**Proposed Tree Preservation Order 234
Boughton Green Road, Former Park Campus**

Response to Formal Notice Dated 24th January 2018

Prepared for The University of Northampton

LUC with SJ Stephens Associates
February 2018

G3b

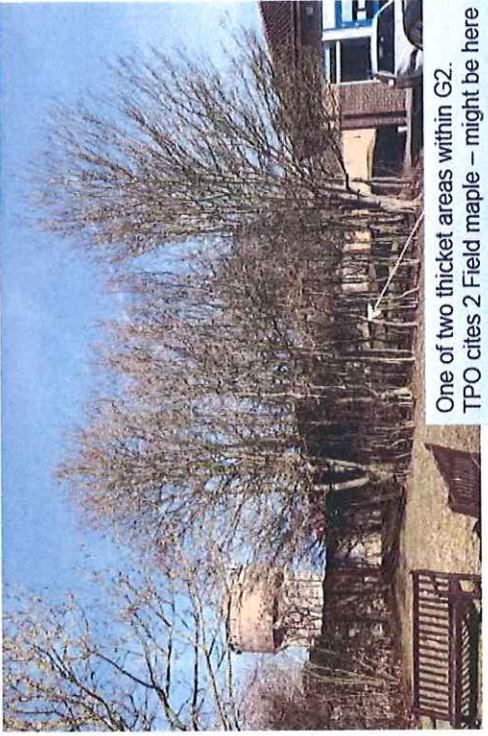
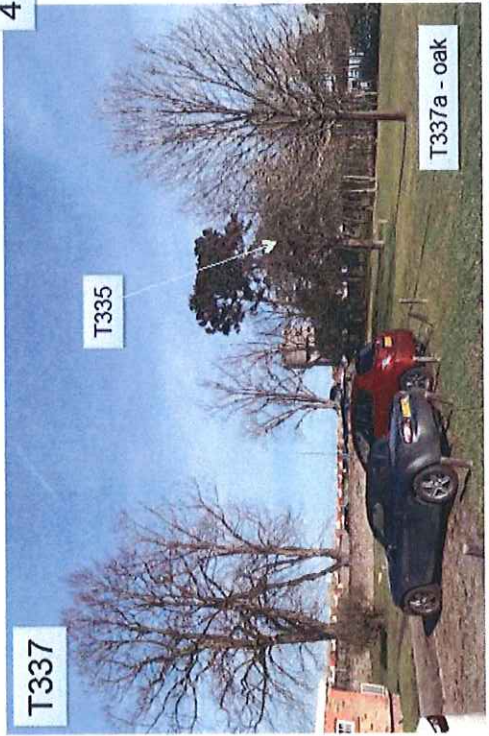
- Group G3b, Norway Maples on mound behind Reception Building: these trees make little contribution to visual amenity or local character being heavily obscured by other trees within Group 3a, are in urgent need of thinning, and are likely to be damaged during demolition of the Reception Building. The proposed trees are neither appropriate for individual or group TPO

G4b

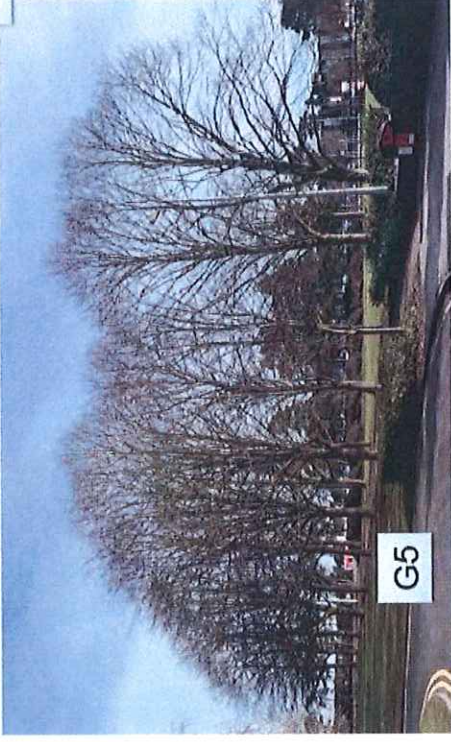
- Group G4b: mostly mown grass with two unexceptional Sorbus (two others have been removed since the 2013 tree survey). The trees make no contribution to screening, visual amenity or local character

W1e

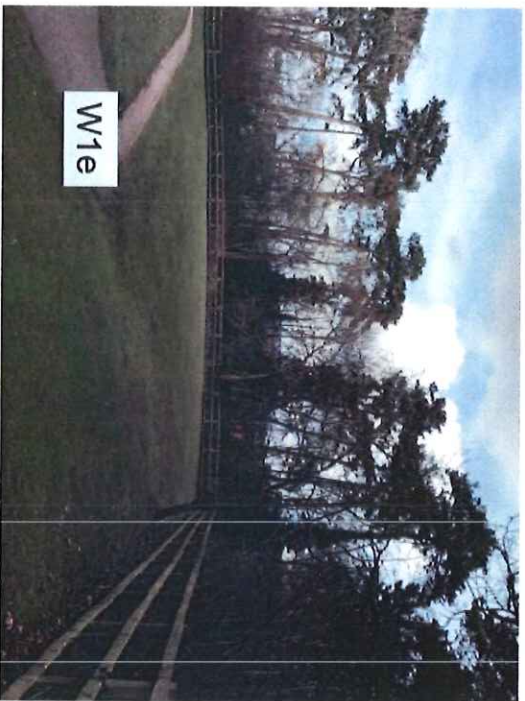
- Sub areas W1a/c/e consist almost entirely of close mown grass with few, invariably small, trees. These trees make no contribution to local character or amenity and should be excluded from the proposed TPO extension
- Sub-areas W1b/d/f consist mainly of low, mainly shrub, planting of species that will have limited height even when mature. There are a small number of trees scattered within these areas the majority of which have distorted crowns and lean heavily because of the shady environment.

We do not consider these areas to be extensions of the woodland as they are outwith the boundary to the wood, have very little overlap of species with those in wood, and provide no contribution to local character or visual amenity per se, or any meaningful addition to the amenity provided by the woodland itself. [W1f is inside the fenced area]

None of these areas are suitable extensions to the existing woodland TPO.
